UNITED STATES PATENT AND TRADEMARK OFFICE

APPLICATION NO.	FILING DATE	FIRST NAMED INVENTOR	ATTORNEY DOCKET NO.	CONFIRMATION NO.
09/532,791	03/22/2000	Takenori Goto	000350	8585

# Office Action Summary

## DETAILED ACTION

**FIG. 1**

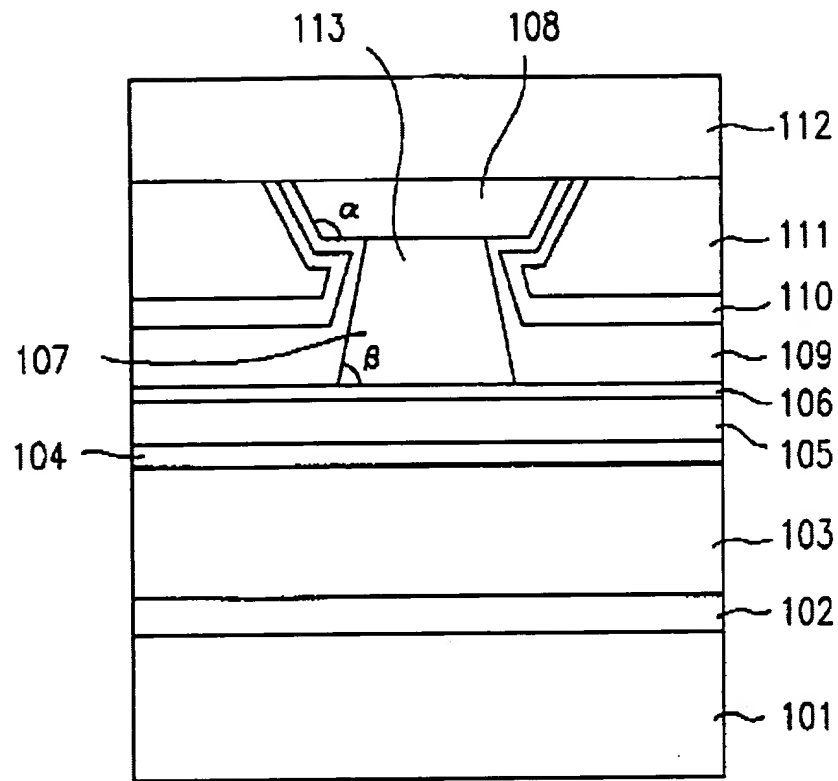
With respect to claims 1 and 11, Ikeda et al discloses a semiconductor laser and a method for producing the same comprising an active layer (104), a lower cladding layer (103), a first upper cladding layer (105), a second upper cladding layer (107) including a cap layer (108) and a ridge (113), a current blocking (109), a first and second protection layers (110, 111), a contact layer (112), a buffer layer (102) and a substrate (101), note cols 8-13, see fig 1.

With respect to claim 2, Ikeda et al discussed the cladding layer has the function of confining light in said the active layer (104), see fig. 1.

With respect to claims 9 and 20, Ikeda et al discussed about the active layer (104), the lower cladding (103), the first upper cladding layer (105) and the second upper layer (107), note cols. 7-15, see fig 1.
